**Reference: Nolen Development Group Revised Sketch Plan
505 West Butler Avenue, Chalfont
TMP: 26-006-096
R.L. Showalter & Associates Job Number 2016-083B**

We offer the following responses to the Gilmore & Associates, Inc. Sketch Plan review dated December 7, 2022:

Reference: 505 West Butler Ave, Sketch Plan Review 2
Nolen Development Group, LLC., TMP# 26-006-096

Reference: 4359 County Line Road, Sketch Plan Review 1
Brooke Enterprises, LLC, TMP# 26-005-006

EXISTING FEATURES PLAN

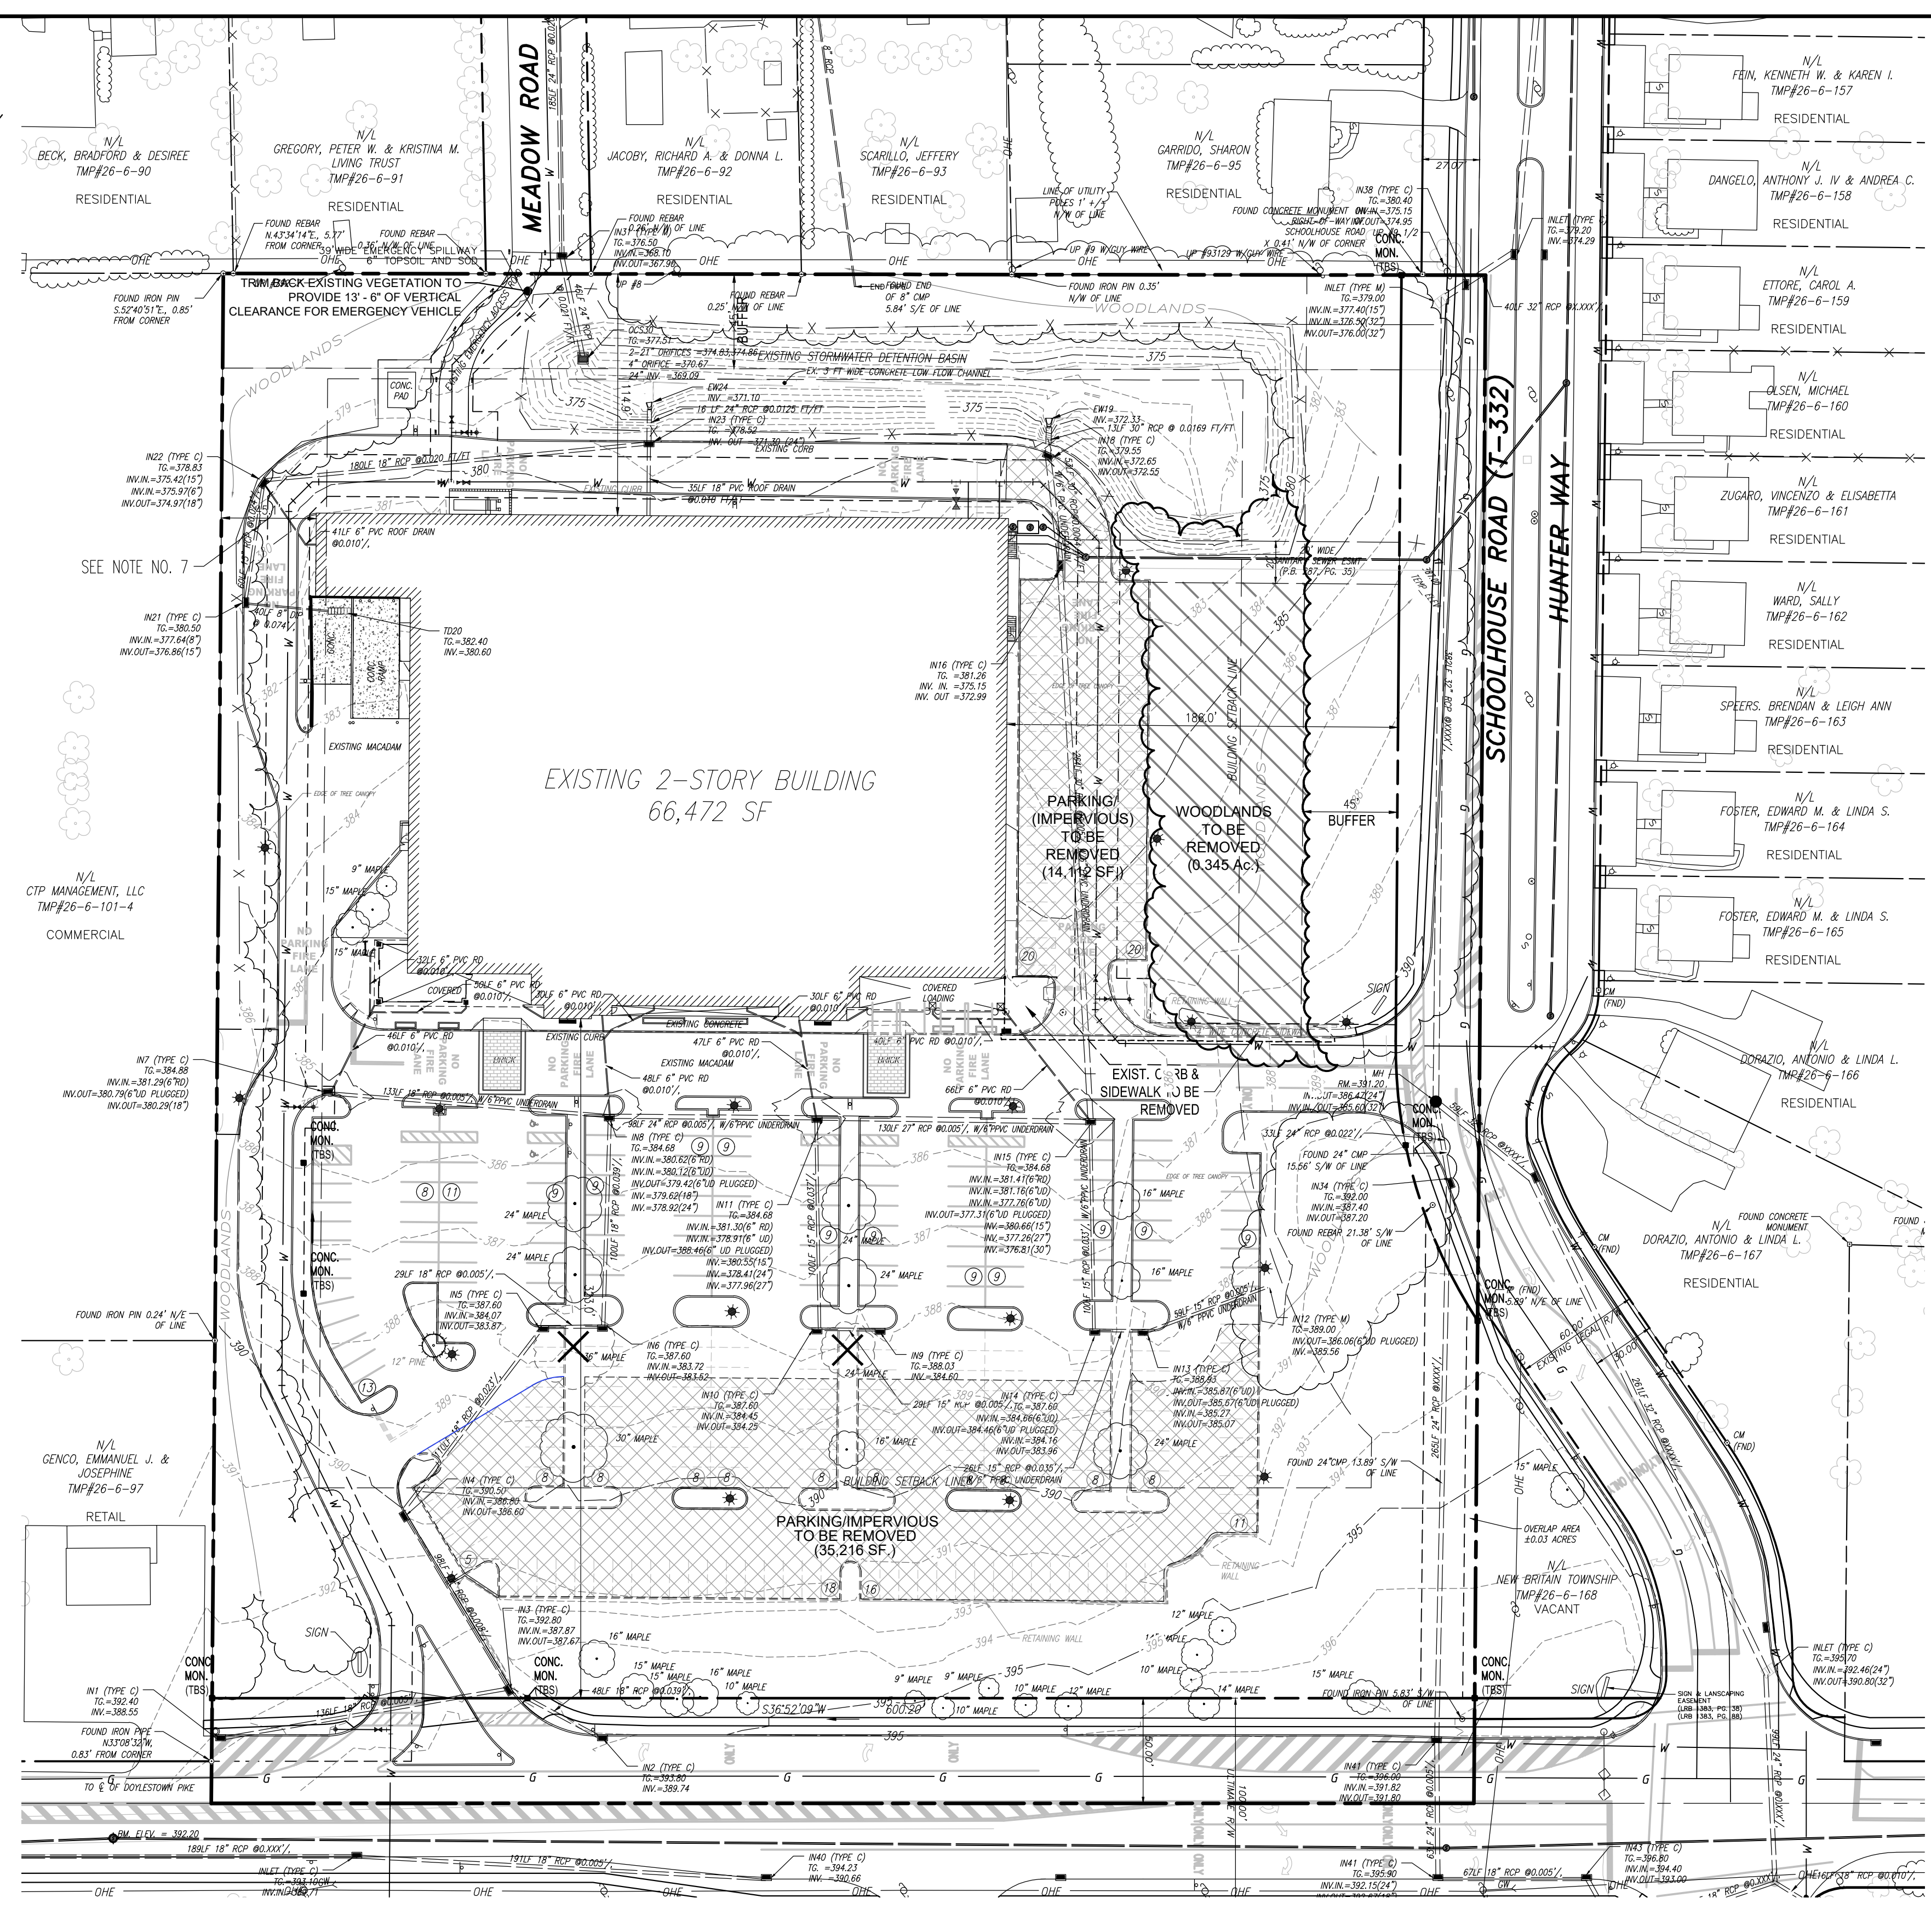
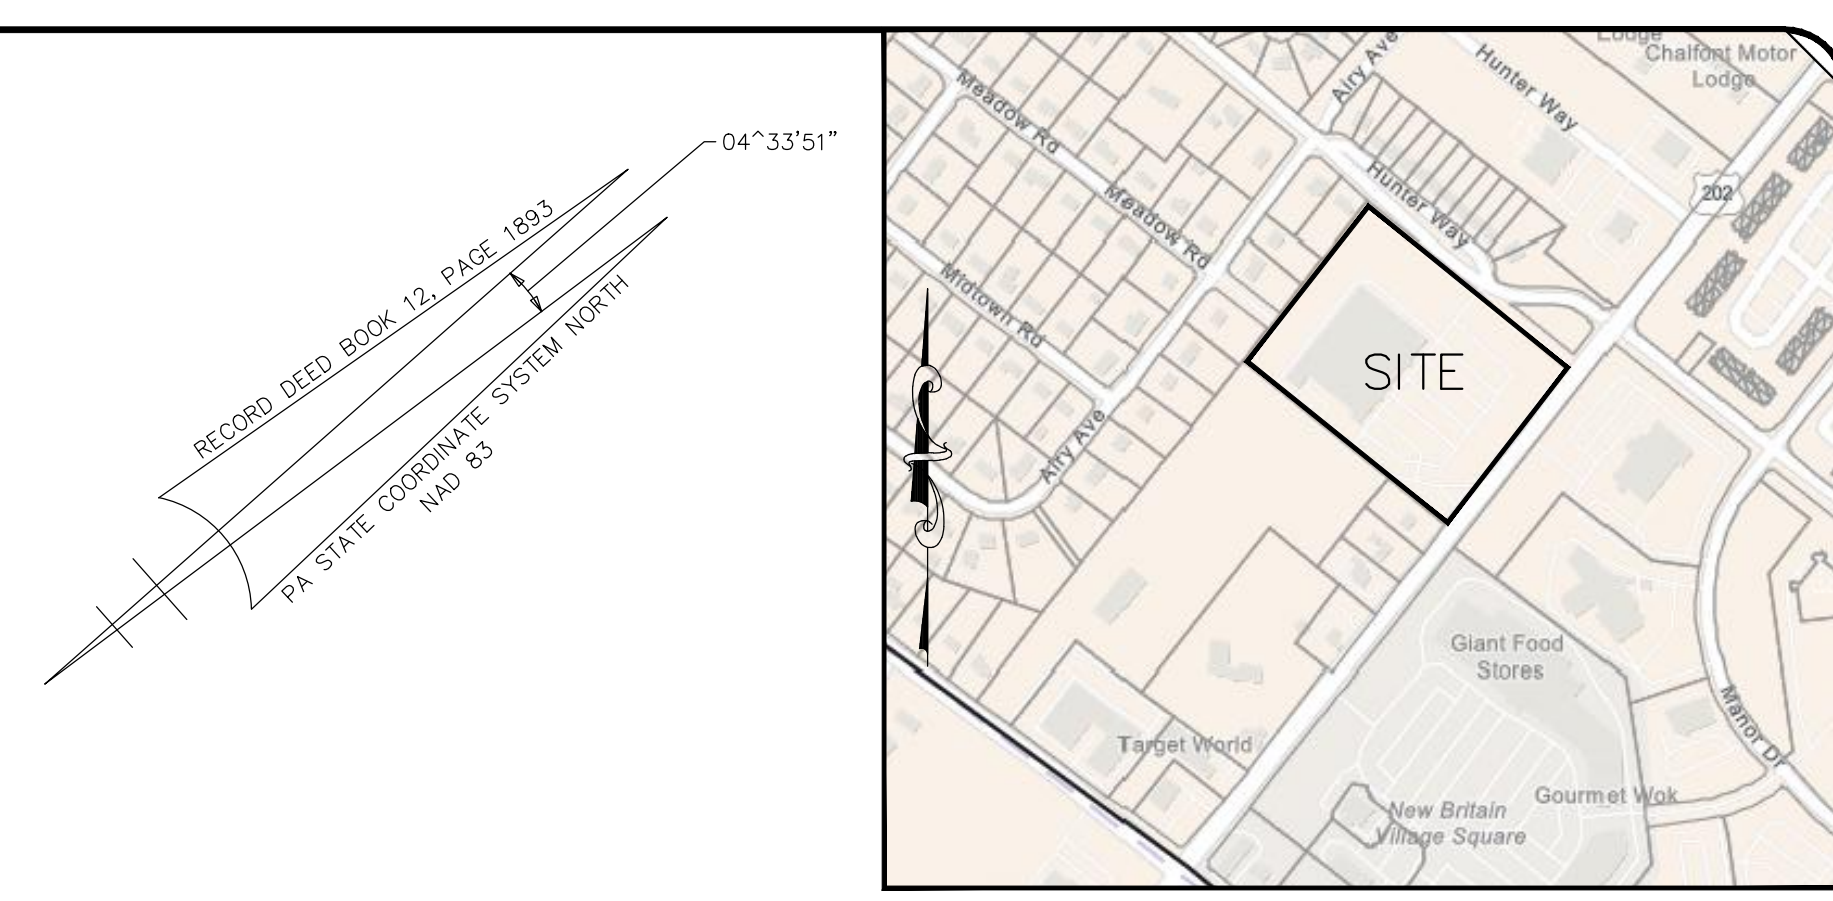
- a. The Existing Features Plan notes a woodlands disturbance area of 0.345 acres. However, the actual area to be disturbed for the proposed building addition and relocated driveway appears to be closer to 0.42 acres. It appears the woodlands between the addition and the stormwater basin will also be disturbed. The area of disturbance shall be clarified prior to any requests for zoning relief.

- b. Woodlands Note #2 on the Existing Features Plan indicates there are 1.904 acres of existing woodlands onsite. This includes tree canopy along the southwestern property line. The existing trees along this property line shall be surveyed to confirm the tree trunks are on the subject property and should be included in the existing woodlands area in accordance with the woodland's definition.

- a. The location of the asphalt being removed is now crosshatched on the plan. See Sheet 2. The areas have been updated in the Impervious Surface Calculations on Sheet 1.

- b. The location and area of concrete being removed is now also shown more clearly on the plan and in the impervious calculations. The concrete to be removed includes existing sidewalk in the area of the addition and existing curbing in the area of the parking lot to be removed.

6. Woodland Disturbance:
 - a. A copy of the Existing Features and Tree Location Plan prepared by Robert Blue Engineers is enclosed. The original woodlands total was 3.12 acres, requiring 50% (1.56 acres) to remain. The applicant is proposing to maintain the minimum

- area of woodlands of 1.56 acres. See resource protection calculations and Woodlands Notes on Sheet 2. No variance is required.
- b. The natural resource calculations on Sheet 2 have been revised to indicate a 50% protection ratio for the C-2 District. The “existing” acreage of woodlands from 1989 has also been added to the table.

LANDSCAPING PLAN

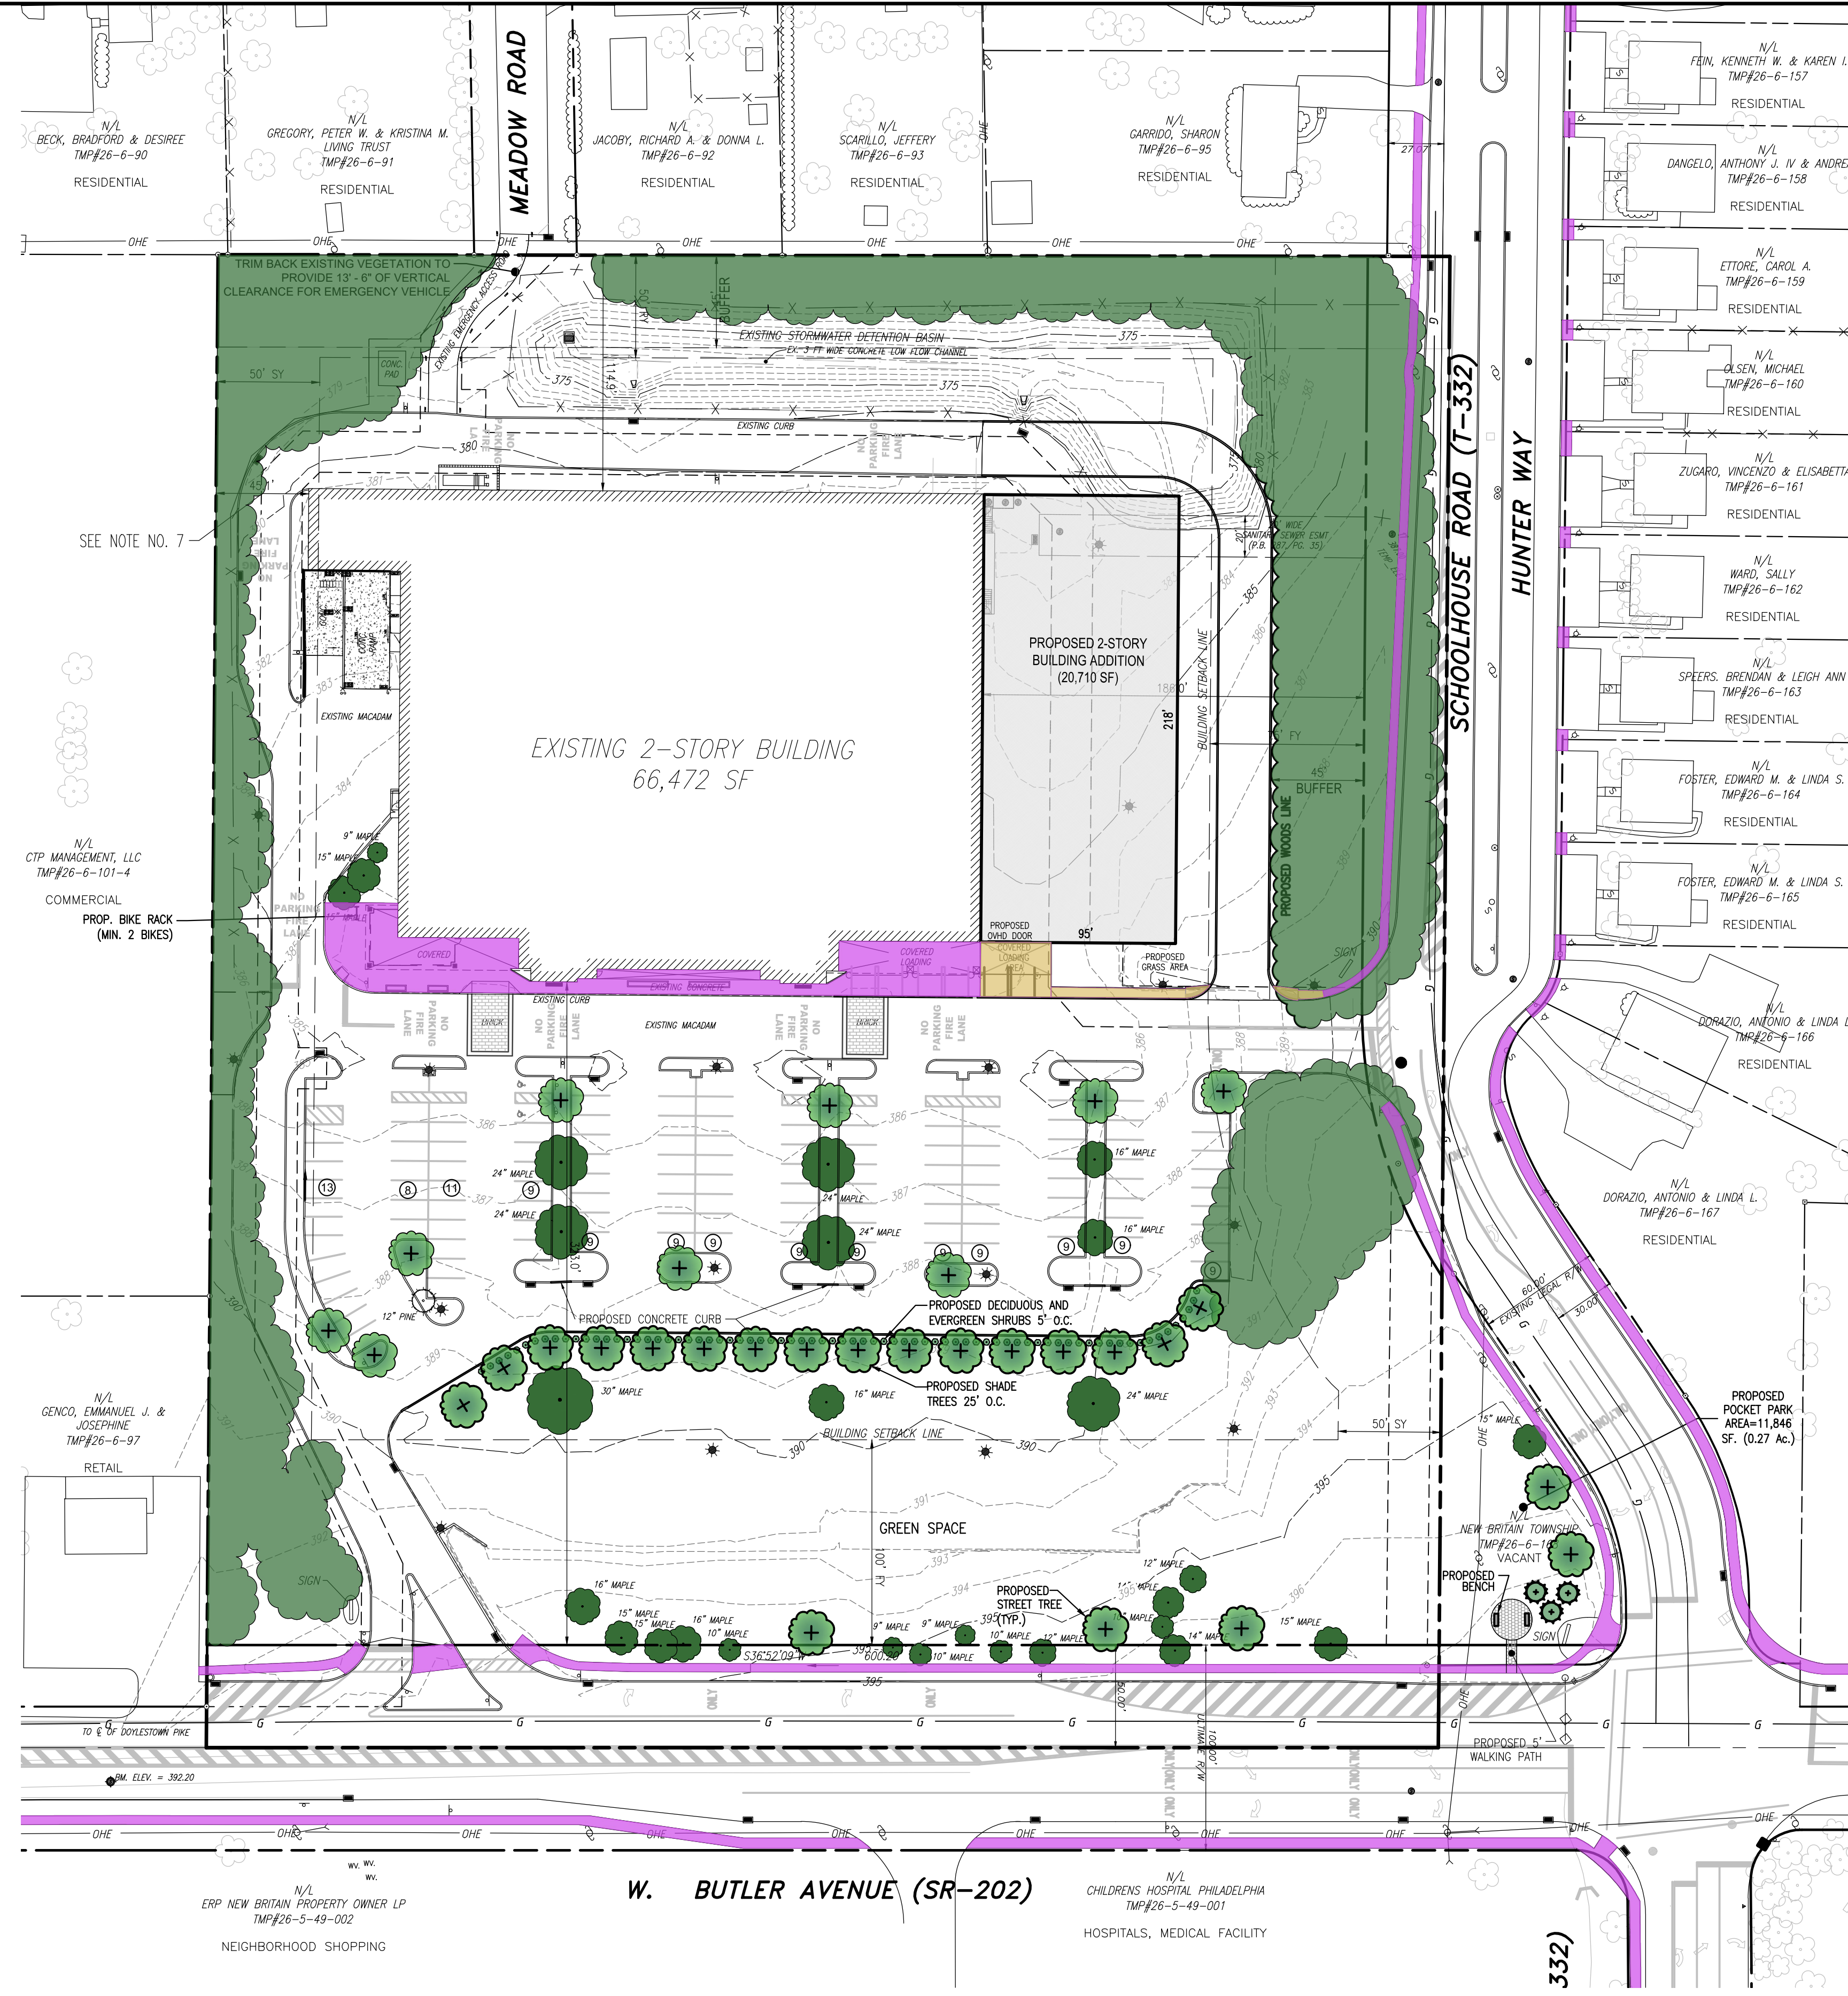
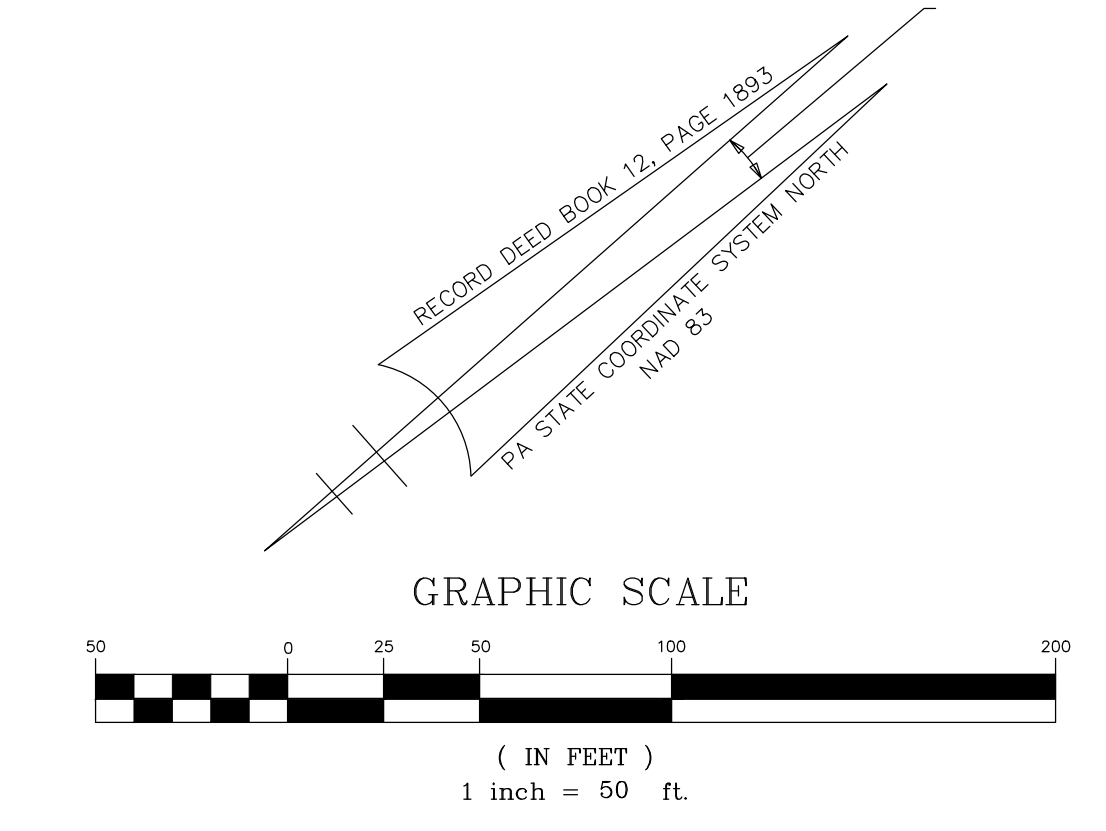
9. §22-713.1 & 3 – All ten-foot by thirty-six-foot planting islands shall contain two shade trees. As requested, supplemental landscaping is proposed within the existing parking area. While the 10' x 36' parking islands are planted, the perimeter islands are not. We recommend a minimum of one shade tree, 2 ornamental, or 5 shrubs be provided at the three 6.5' x 36' islands adjacent to the front of the building.

6. Additional landscaping as required has been added to the plan. The planting requirements will be incorporated in the Preliminary Plan Application.
 - a. Shade trees have been added to the planting islands where no utility conflicts exist.

- b. Shade trees have been added to the parking row planting strips spaced at 25 ft where no utility conflicts exist. Shade trees have also been added along the parking area perimeter as recommended.

- c. Shrubs have been added spaced 5 ft apart along the parking area perimeter as required.
7. A lighting plan will be incorporated in the Preliminary Plan Application.
